## **WOMEN'S BUILDING**

**ADA ASSESSMENT & SURVEY**

January 8, 2015

Re: ADA Accessibility Survey and Assessment - Women's Building

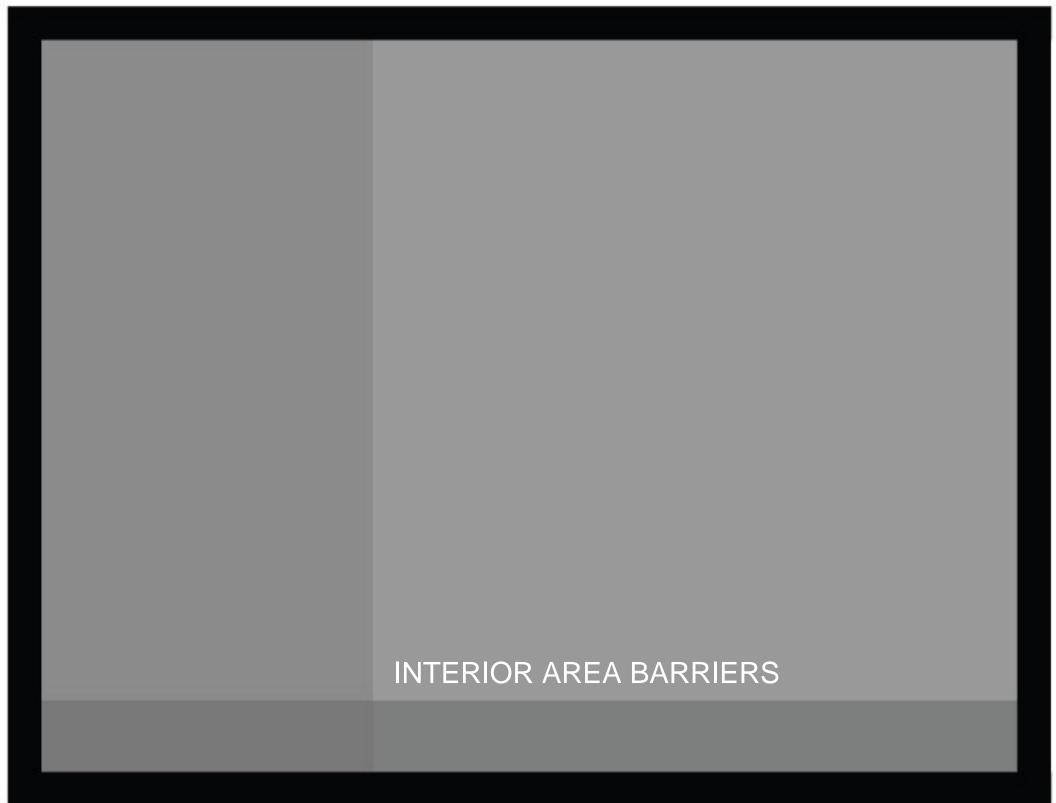
Barrier Type:	Handrail Extension - Bottom
Code References:	2010 ADAS 505.10.3
Performance Sta	andard: No Quantity: LF As-built : 0
Barrier Description:	Bottom handrail extension not sloped for length of one tread
Findings:	Bottom handrail extension not sloped for length of one tread
Rec. Solution:	Provide accessible handrails at both sides of stairway
Barrier Severity:	2 Recommended Cost Est \$0.00 Facility Function: Public Status: Open
Implementation	12 Hecommended 3000 Joseph Marine, 17 doller 3000 Joseph
implementation	Priority: 1 Implementation Phase: Implementation Date:
